Master Sign Plan

15-090MSP – BSD Scioto River Neighborhood District

Big Sandy Superstore – Dublin Village Center 6825 Dublin Center Drive

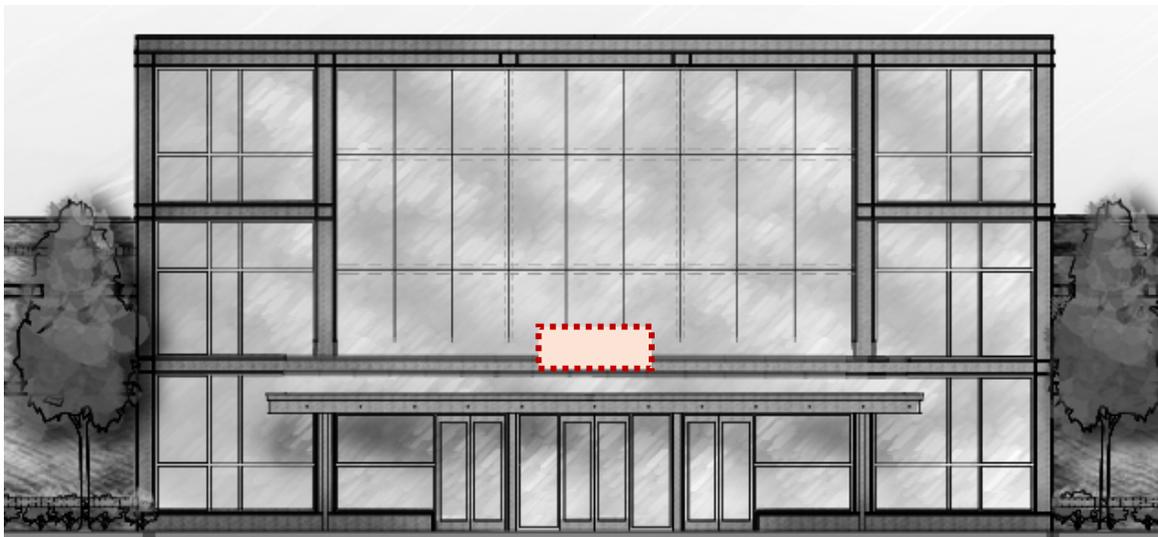
The red boxes in the diagrams are an approximation of the maximum allowable sign area. The yellow boxes describe the approximate area of the proposed signs.

Maximum allowable area (50 square feet)

Main Entrance Detail

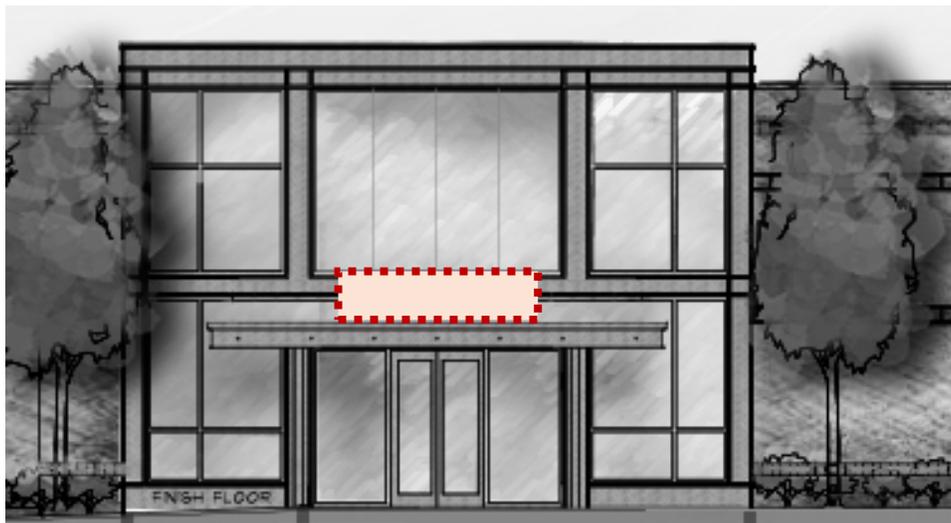
The proposed primary entry sign was sized to be proportional to the scale of the entry. The entry atrium is 3,760 sq. ft. The sign area is 10% of the atrium entry area. The sign is 374 sq. ft. in size. Code allows 1/2 sq. ft. of sign for each lineal foot of building wall. The center section of the building façade is 160 lineal feet, which would result in an allowance of an 80 sq. ft. sign. Maximum size allowed is 50 sq. ft. The "Big Sandy" text is red channel letters is attached to the main entry curtain wall system. The "superstore" is a script font, with open face channel and LED tube outline, mounted to the entry canopy. The image illustrates this design approach. Both type face styles are part of the Big Sandy trademark. 20'-2" is the proposed sign height.

Approval is recommended of the Master Sign Plan to permit one primary wall sign that exceeds the Code requirement for size & height and two secondary wall signs that exceed the number of allowable wall signs for a single tenant, entry façade and exceed the allowable distance from the front façade, and exceed the allowable size, with the following condition:
